Booster Envelope modification proposals

F. Renaudin
18/03/2014

Analysis of JAMA Proposal
ISO N1042

JAMA prop. and 135P95

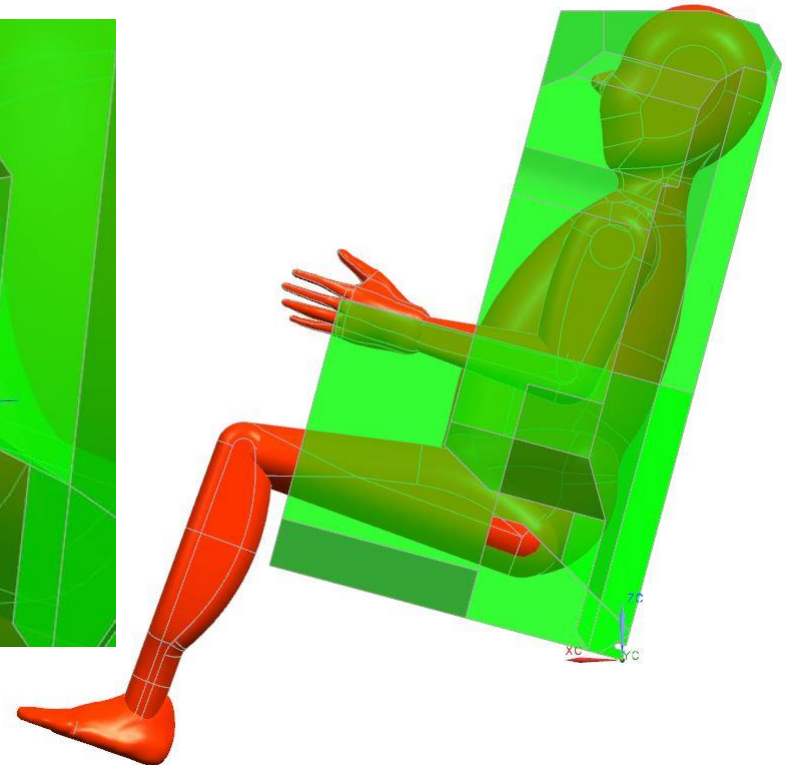
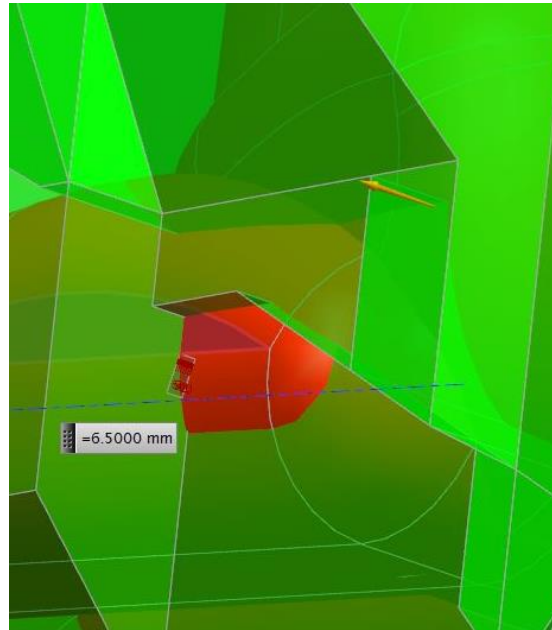
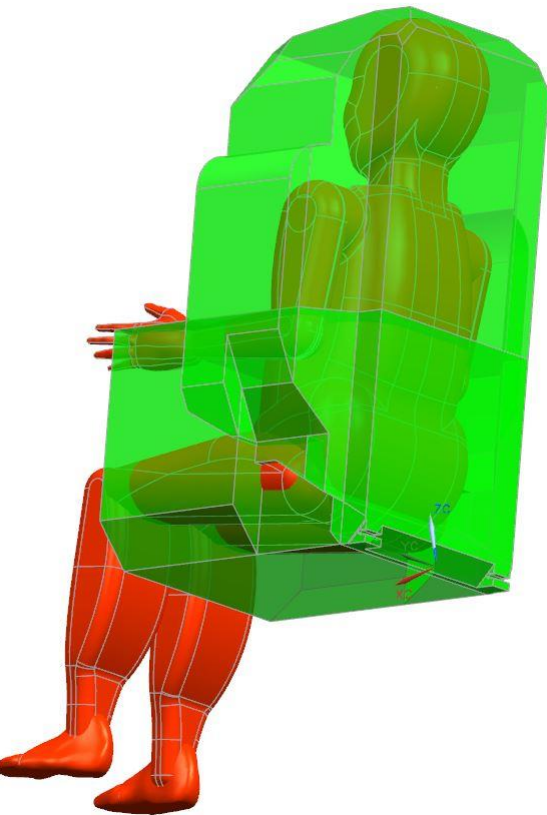
- No enough space for the 135 P95 hip breadth

Lap belt Guide

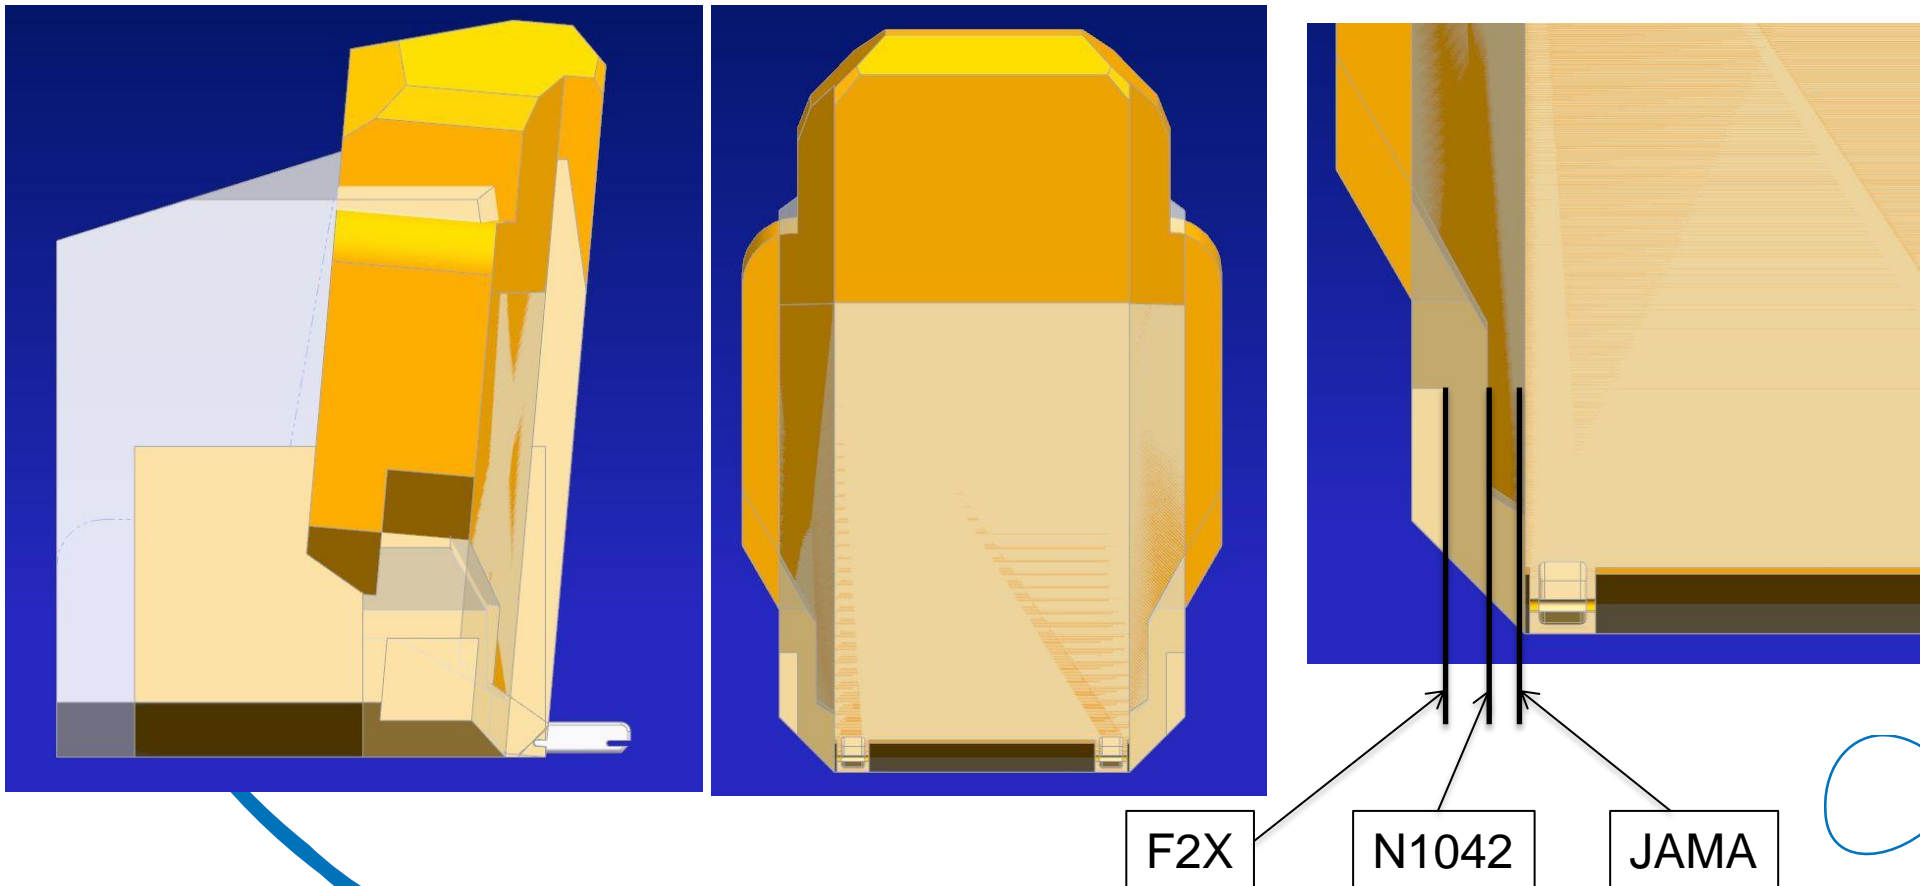
- JAMA Lateral recess very important compare to F2X

Current situation with N1042

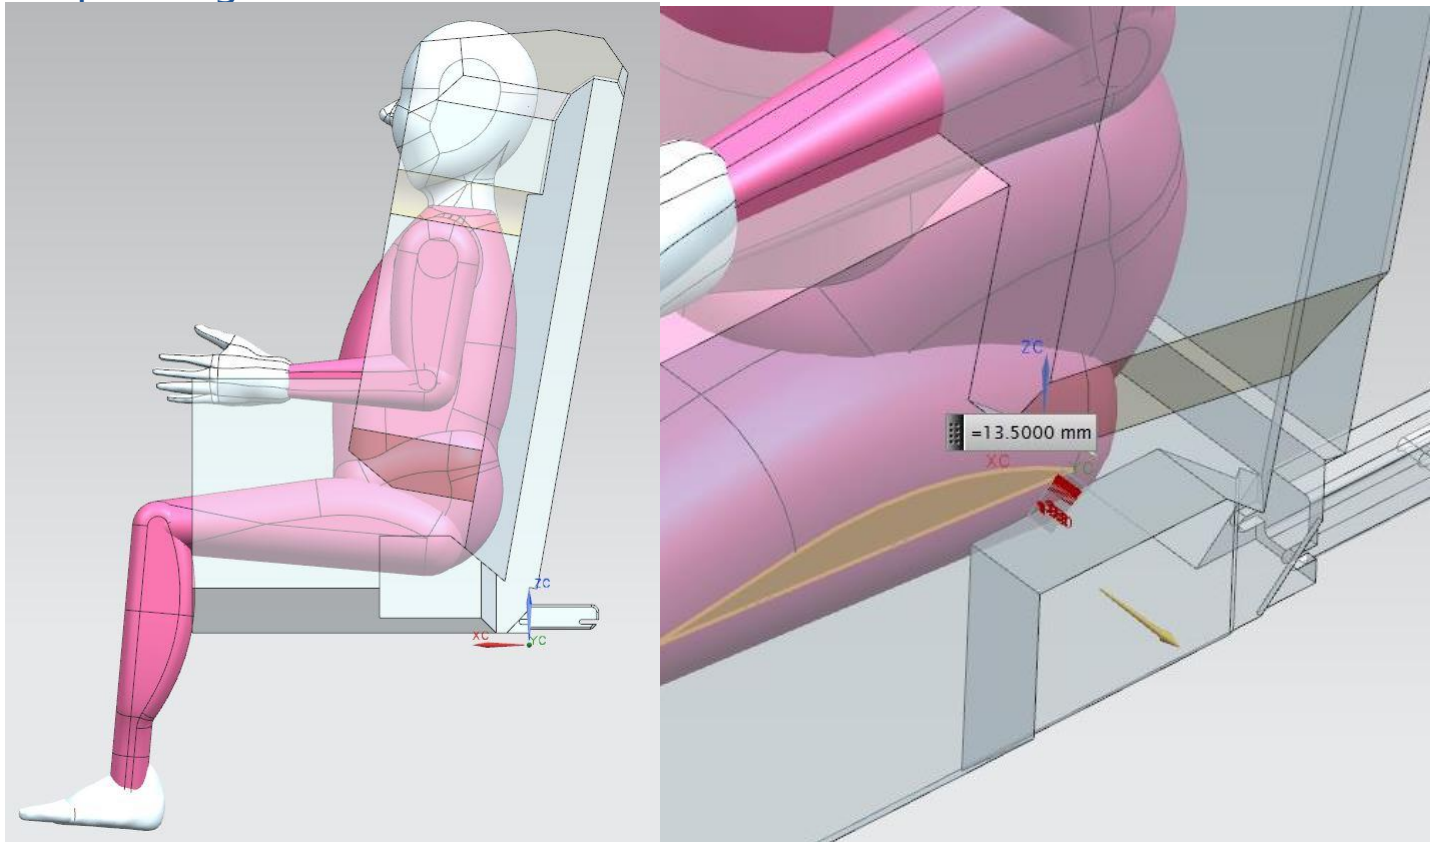
- The booster CRF must accept the installation of a 135 P95 Child
- The current fixture doesn't leave enough space (hip width) in order to integrate lap belt guides in the CRS

Lap Belt Guide

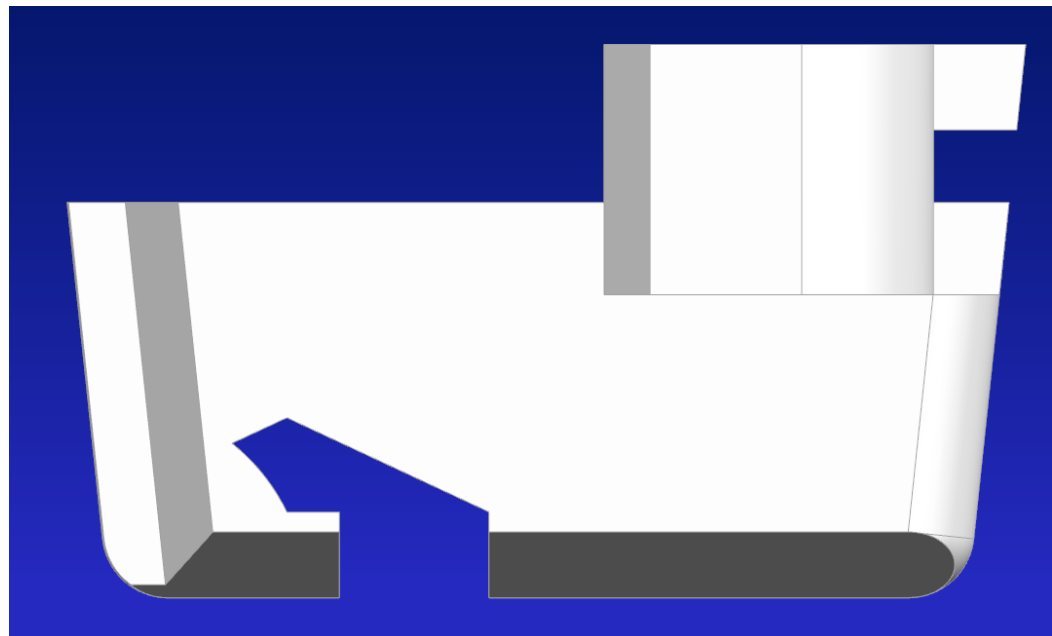
- Assumptions
 - Keep the current recess up to extreme possible position given by R16 gabarit concerning the lap belt load bearing point.
 - Enlarge the recess above the 150 mm radius which defines the maximum position of buckle

Lap belt guide

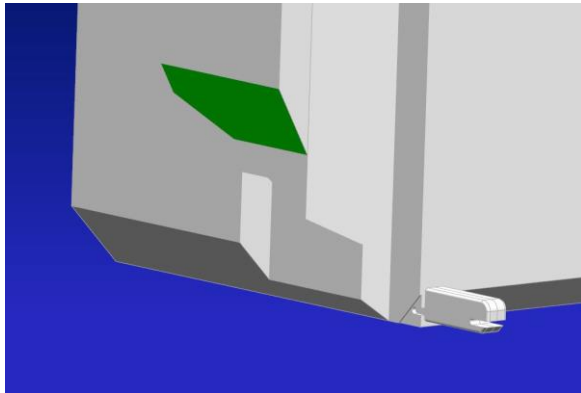
- Using available space up to 440 mm width

Lap belt guide

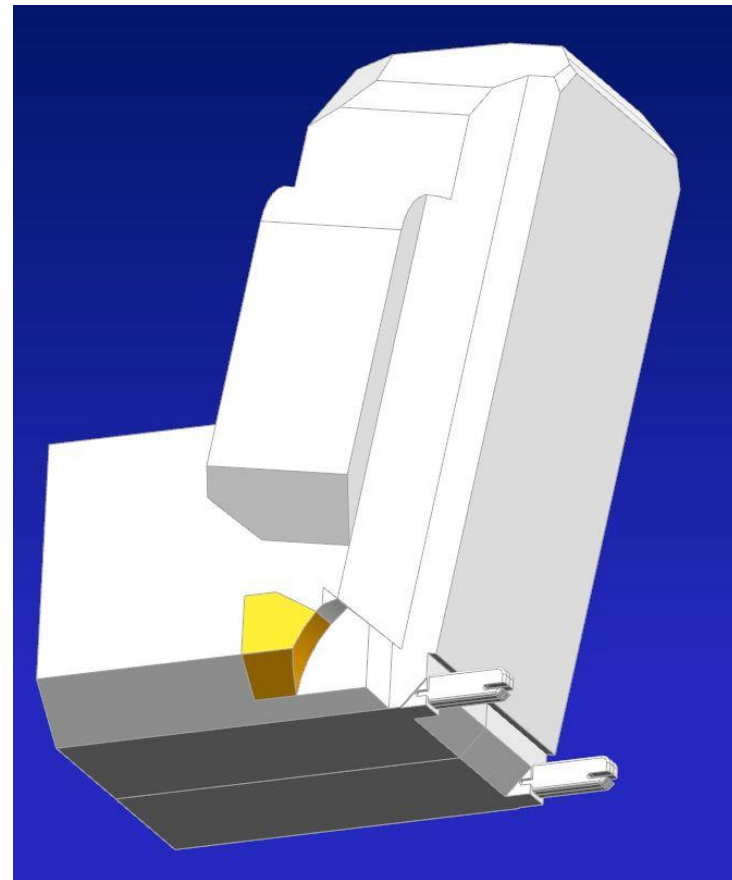
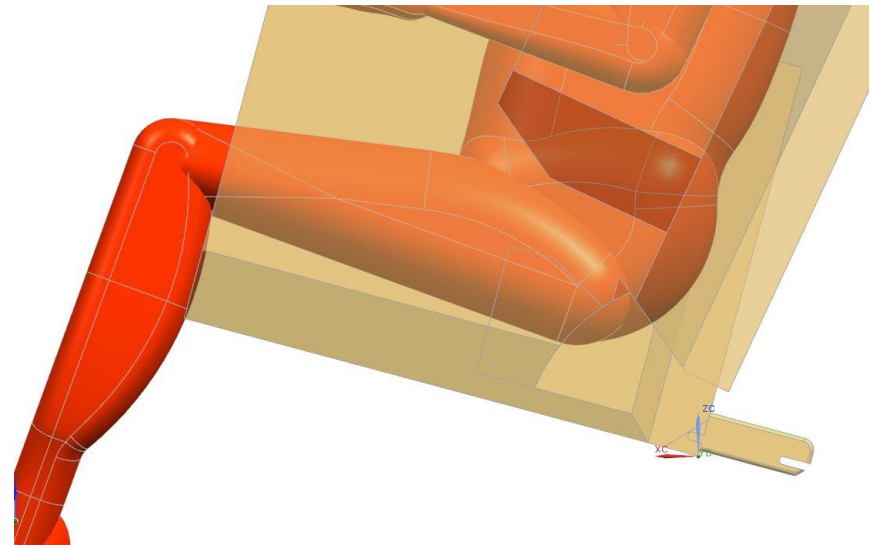
- More space available to implement belt guides with 135 P95

Lap belt guide

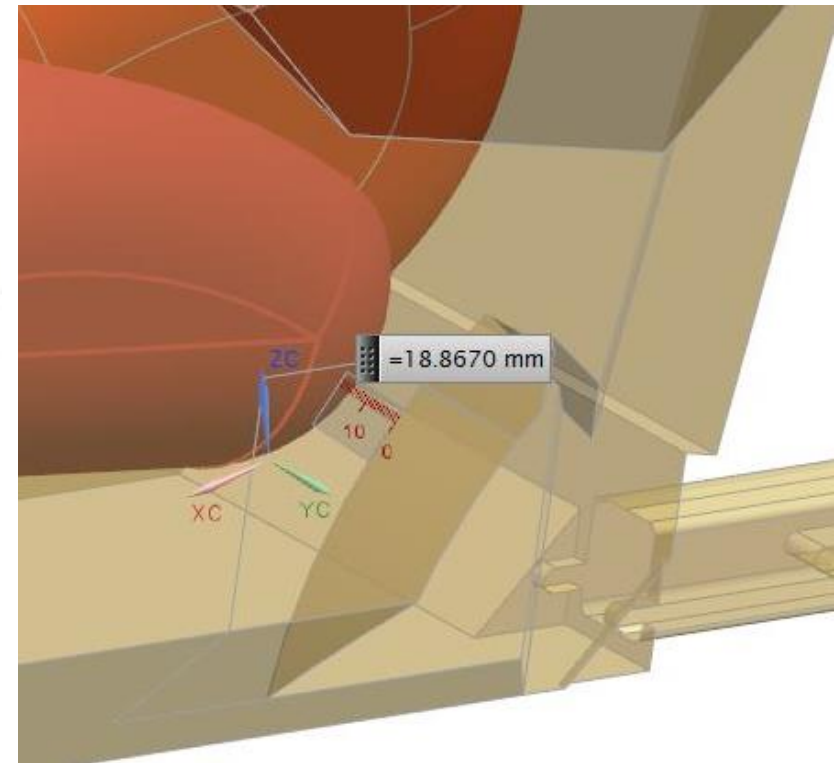
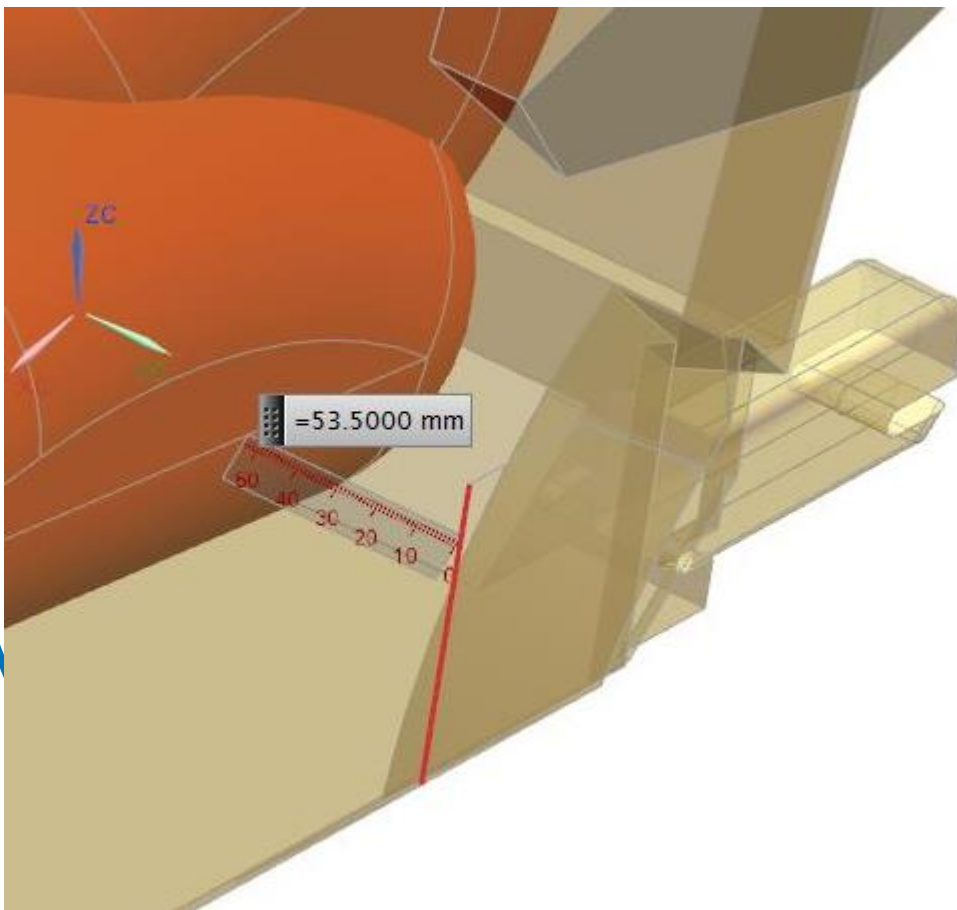
- More space available to implement belt guides with 135 P95

Side Wing

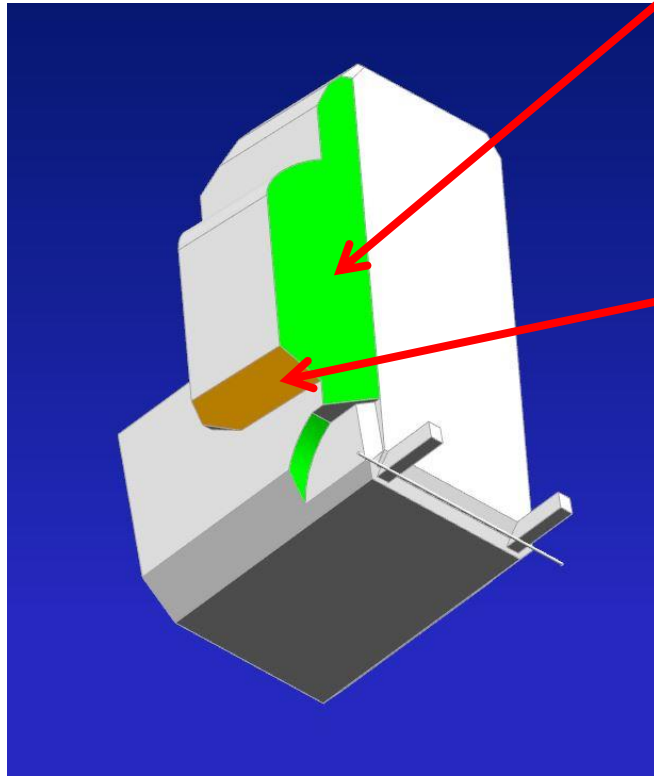
Modification of side panel for better side protection

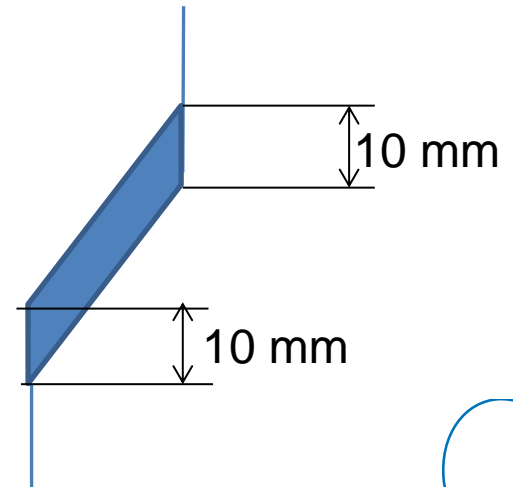
Material removal
for better compatibility with armrest
(partly JAMA requirement)

Backrest thickness

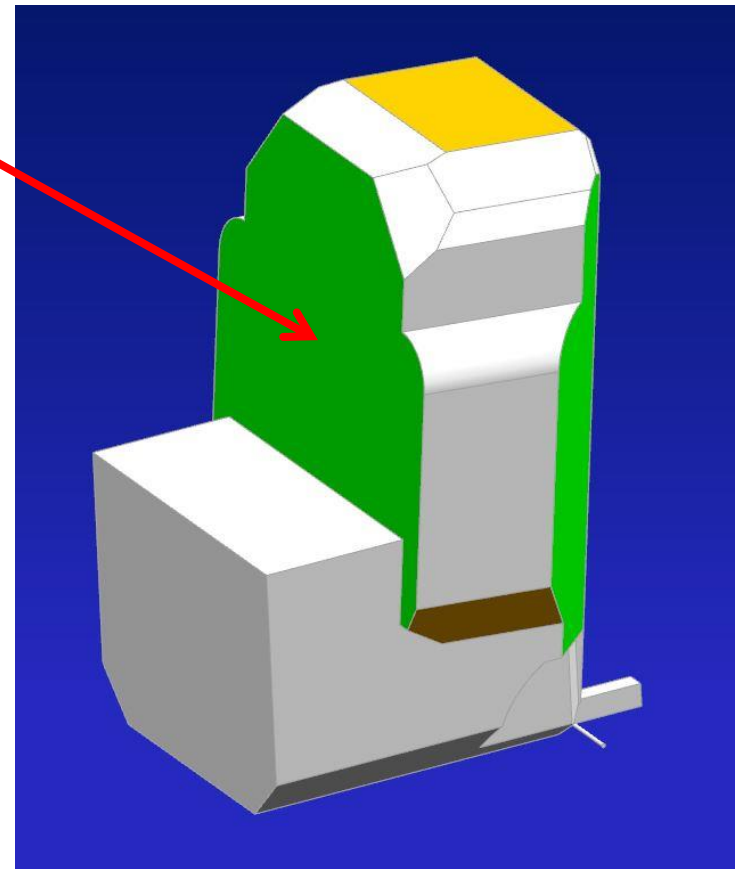
+10 mm for better side protection (CLEPA requirement)

Modification of top surface

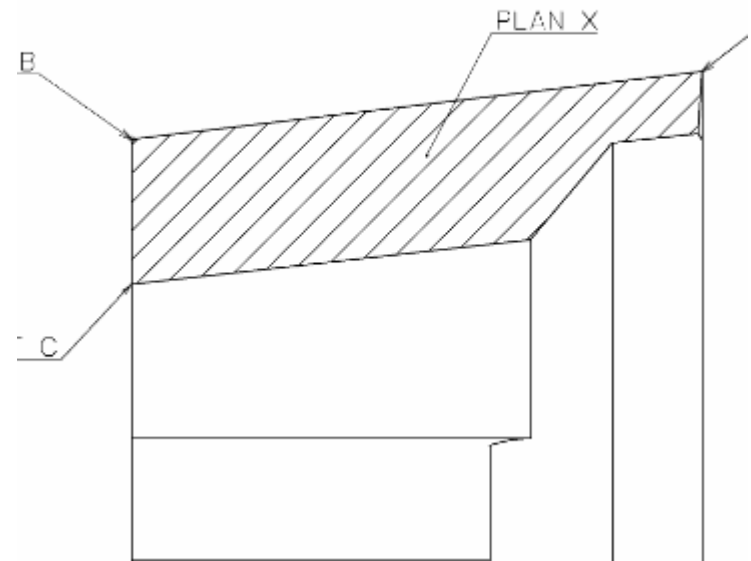
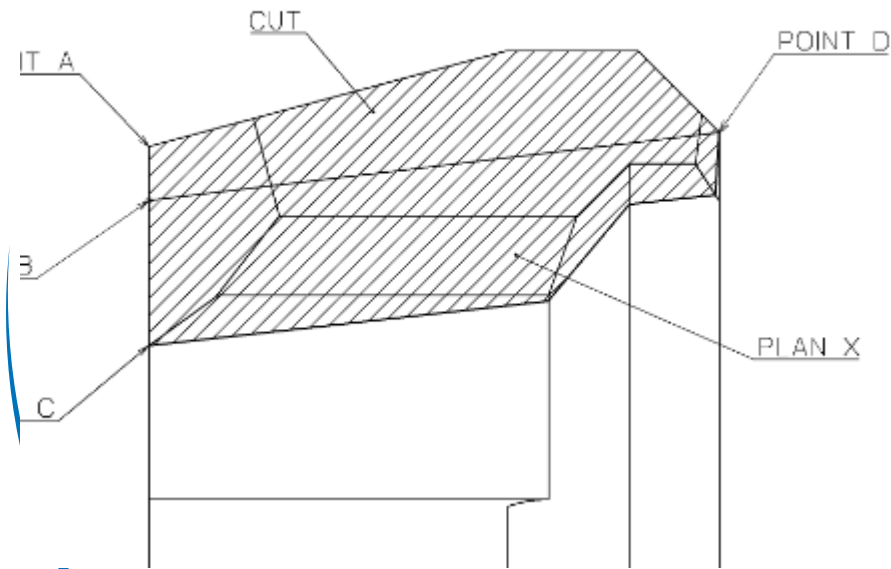
- JAMA requirement in top area

Modification of top surface

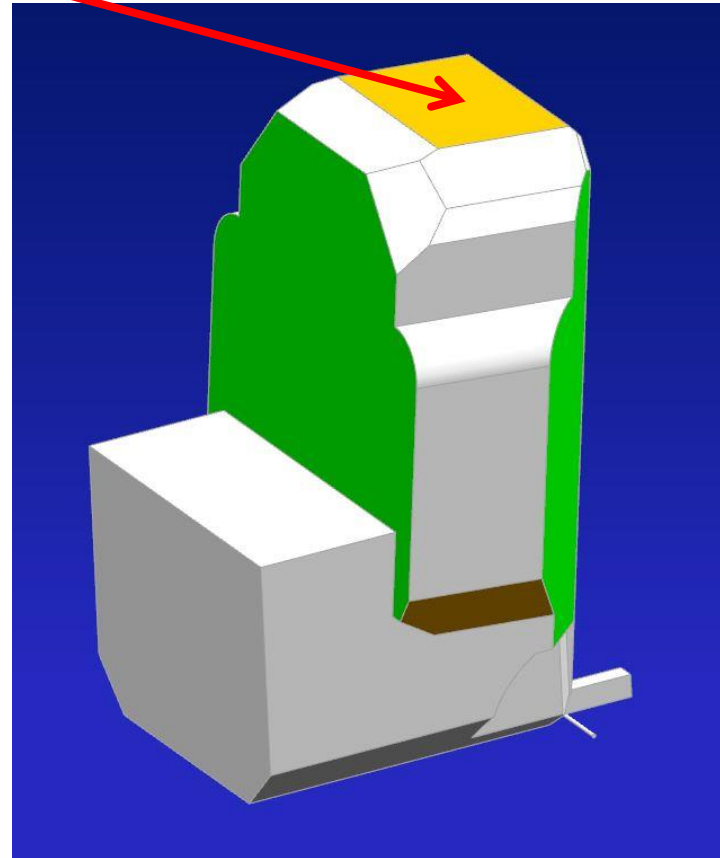
- -25 mm compared to N1042 (JAMA requirement to decrease this area)

- This modification is acceptable for 135 cm if Q10 is not used for lateral impact
